April 25, 2002

Docket No. 03005980
Control No. 130955

NRC REQUEST FOR ADDITIONAL INFORMATION ON THE SAFETY LIGHT CORPORATION "WORK PLAN"

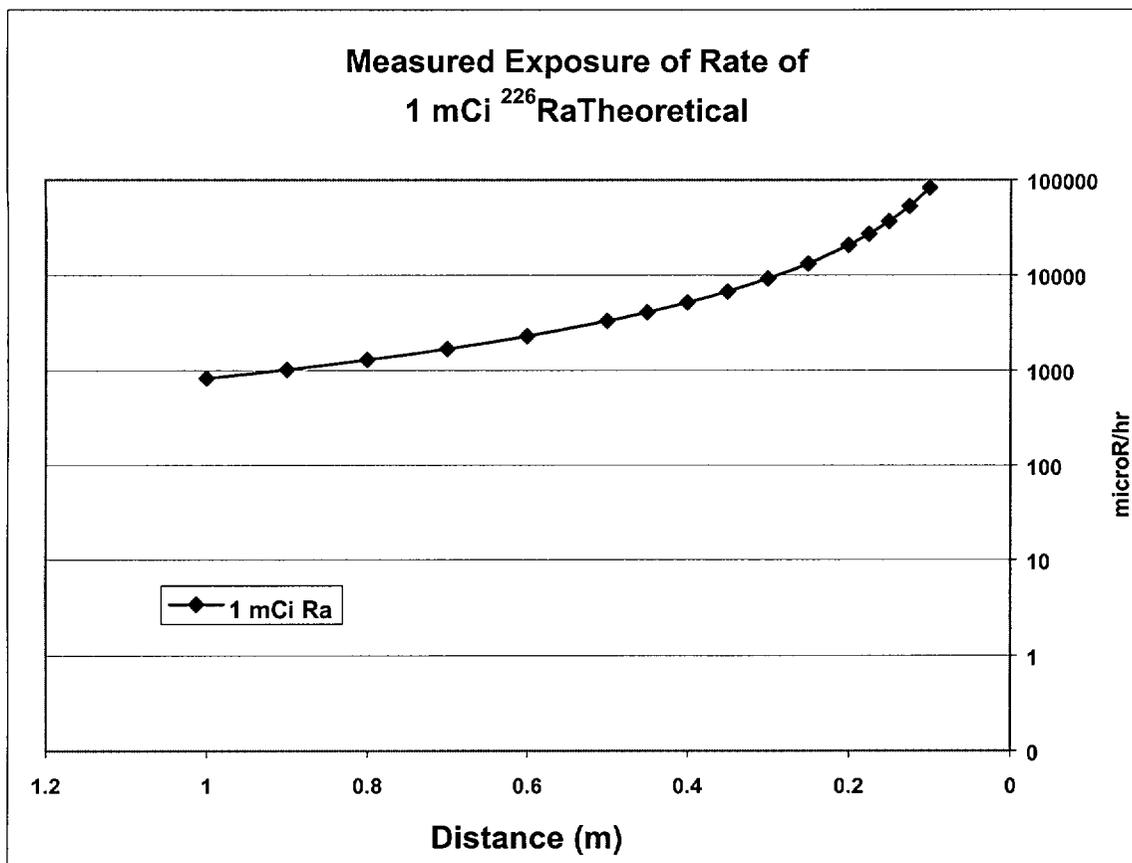
10. Section 11.1 states that a dose vs distance conversion will be used to determine activity. Please provide this information or indicate where this information is located in the Work Plan.

To quantify the activity, the exposure rate of an item with a near point geometry will be measured at several distances and compared to the theoretical exposure rates from a one (1) milliCurie point source of radium, as shown on the following graph. Items with a very low activity may be grouped to reduce measurement error. Data obtained during the project will be plotted and the resulting lines compared to determine the shape of the measured data.
